## SITE INSTRUCTION

### SI A20

**PROJECT** : Forestside  
**PROJECT #** : 1331.15  
**DATE** : May. 10, 2022

**Title:** Revisions to plans as itemized.

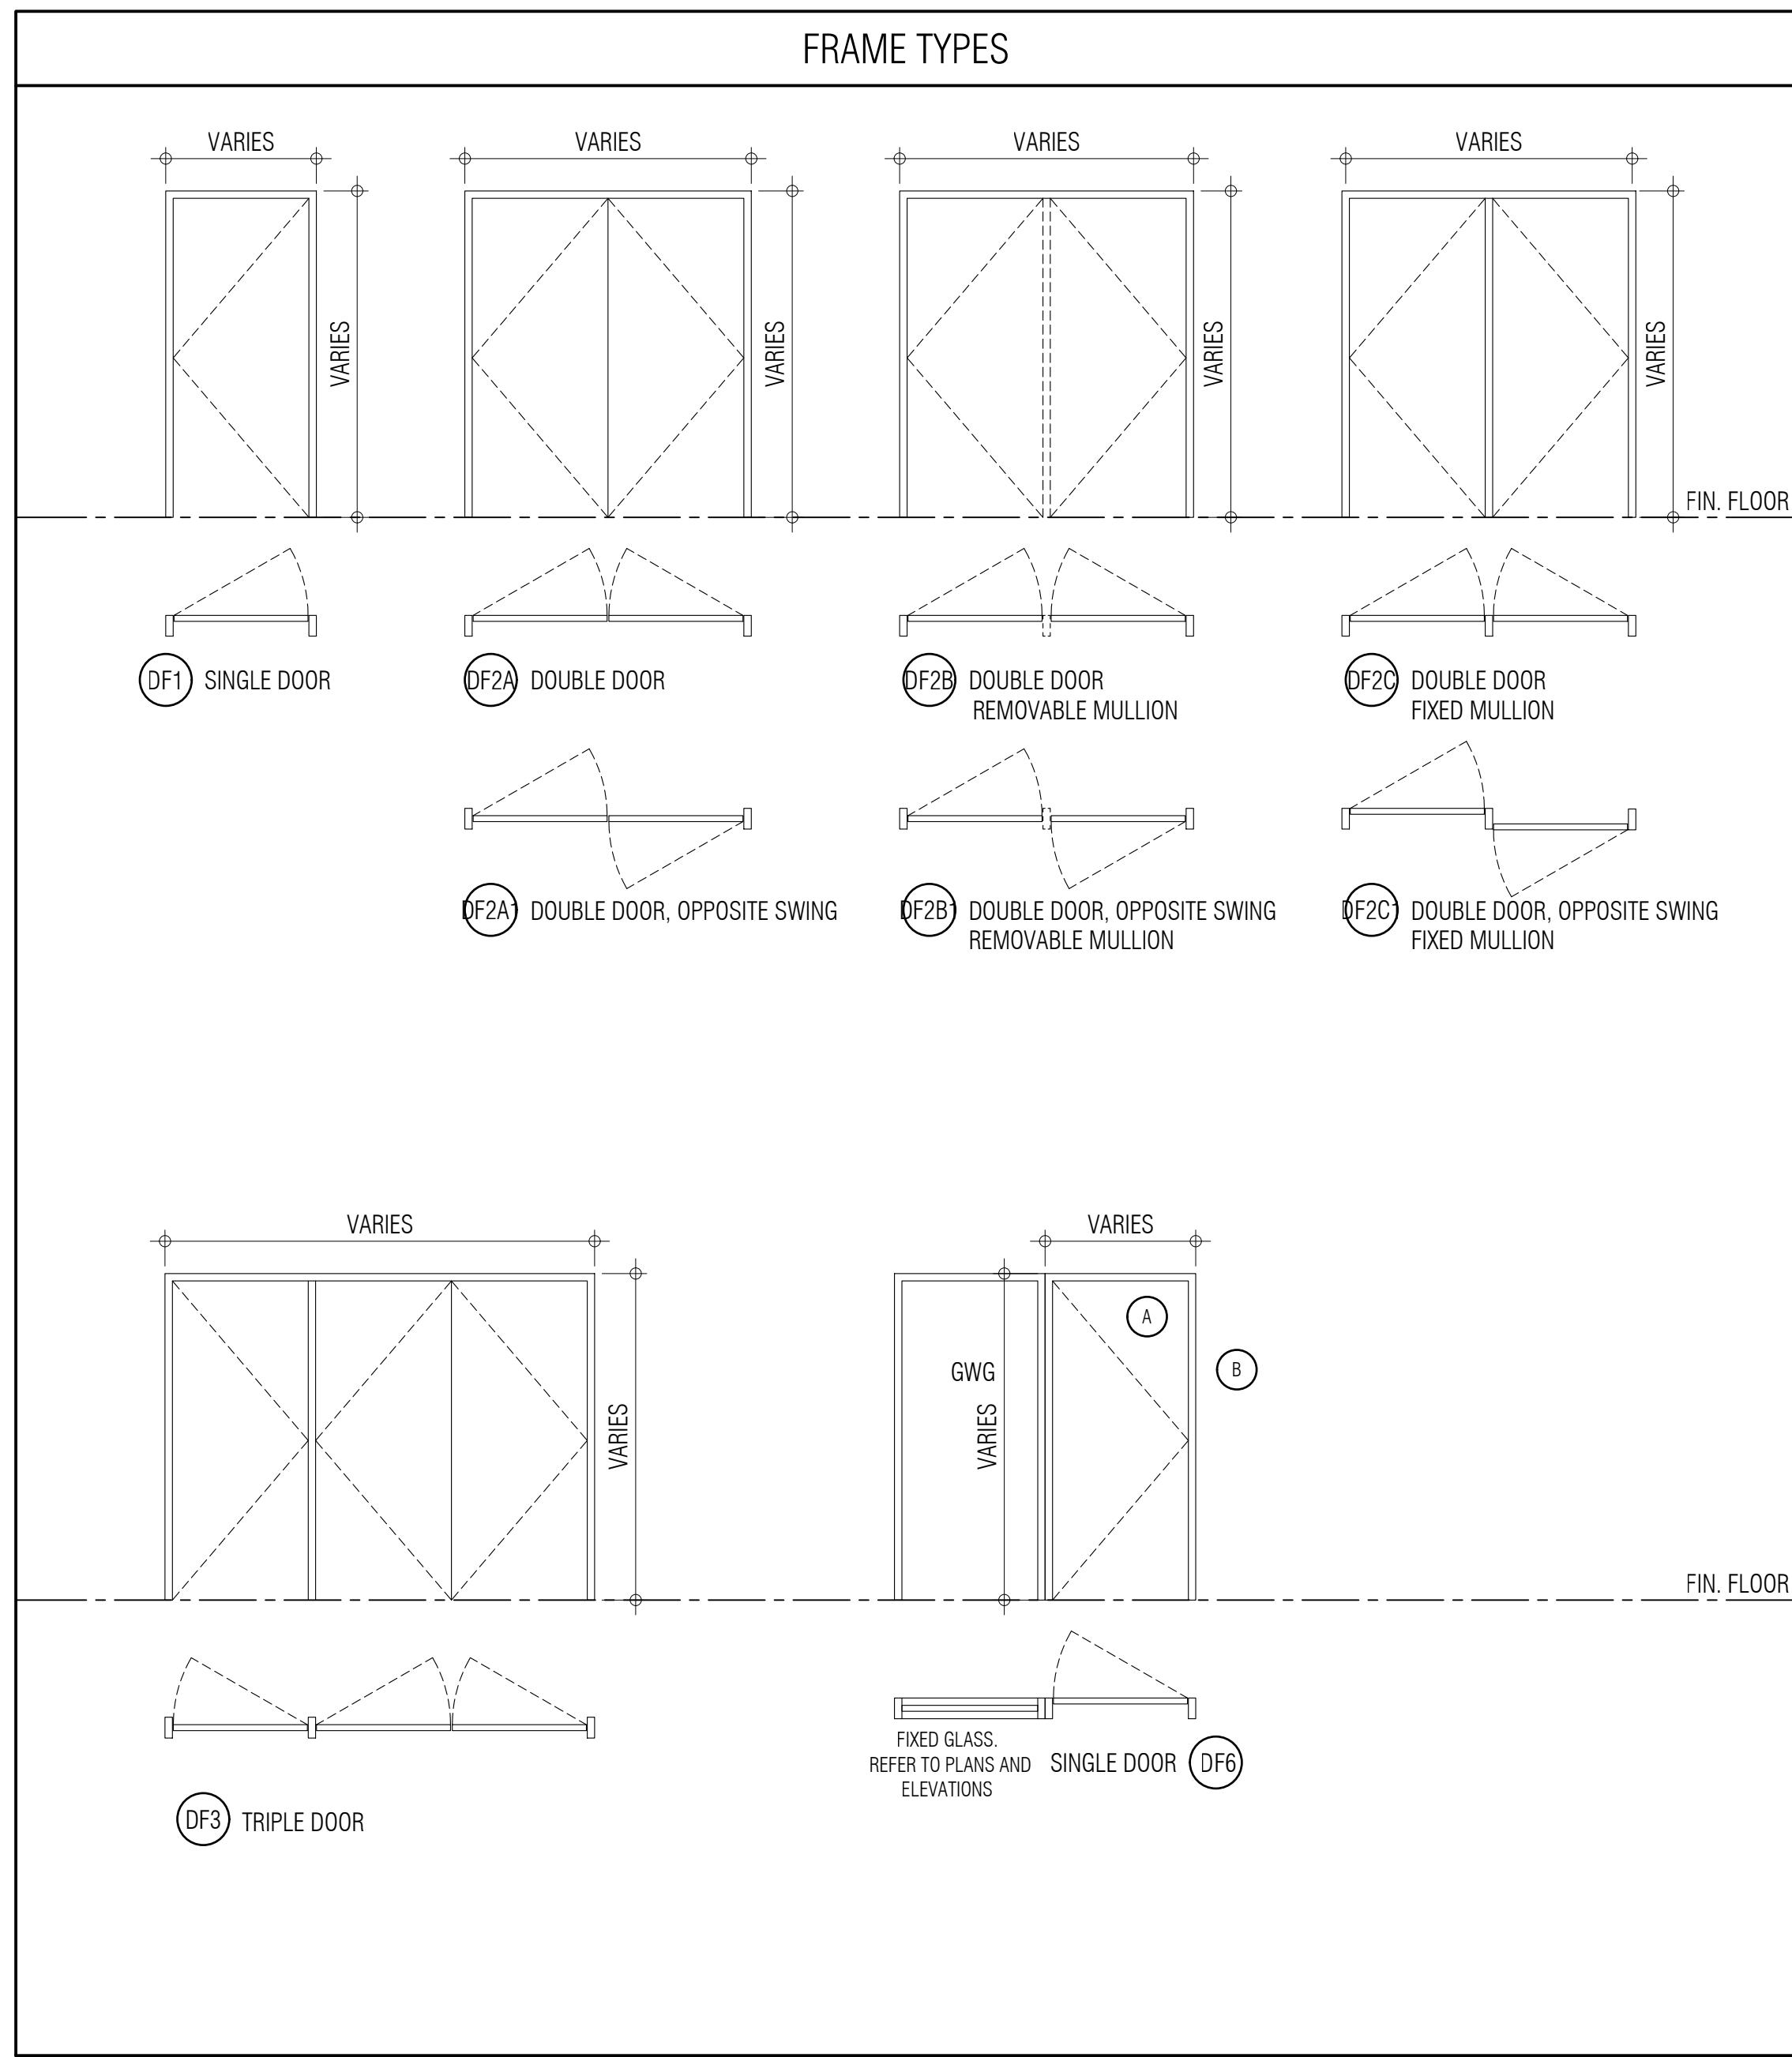
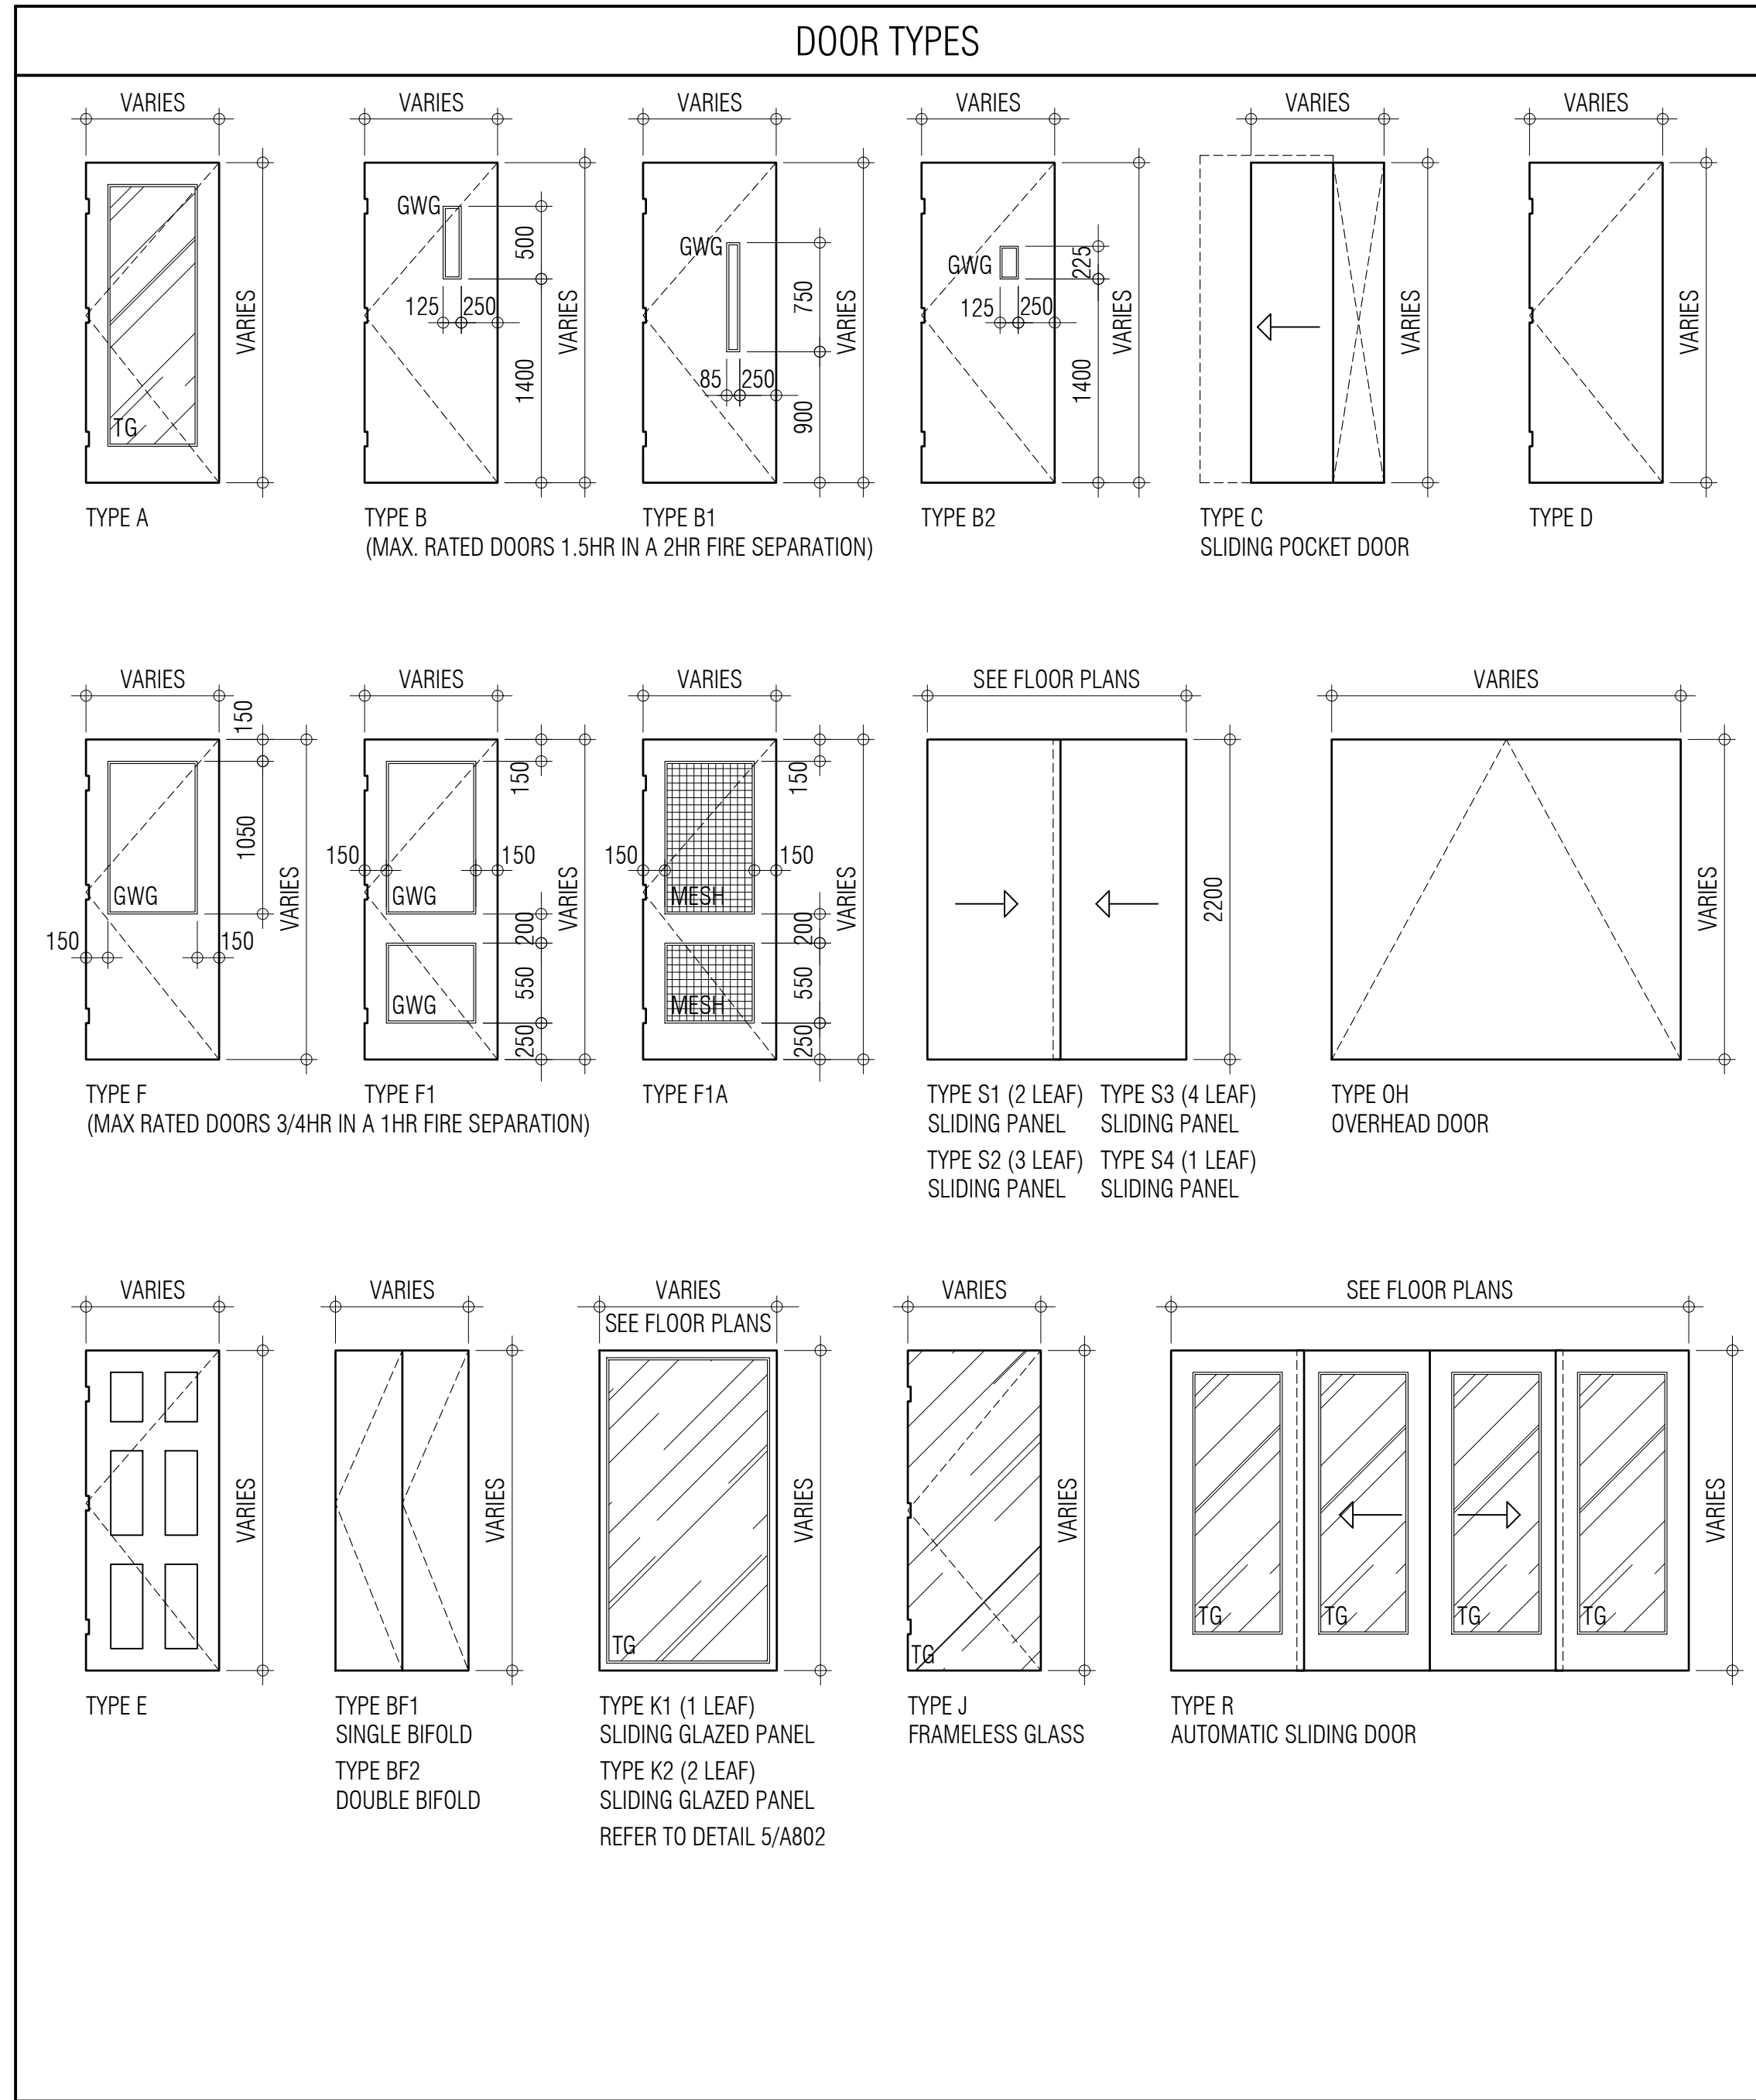
Reference:		Changes:
A102	Door Schedule	<ul style="list-style-type: none"> <li>Remove Door Label B105 from door schedule.</li> </ul>
A211A	P1 Underground	<ul style="list-style-type: none"> <li>Remove Small electrical room walls and door under building D.</li> </ul>

**Reason:** Revisions to plans to remove small electrical room under building 'D' as per site request.
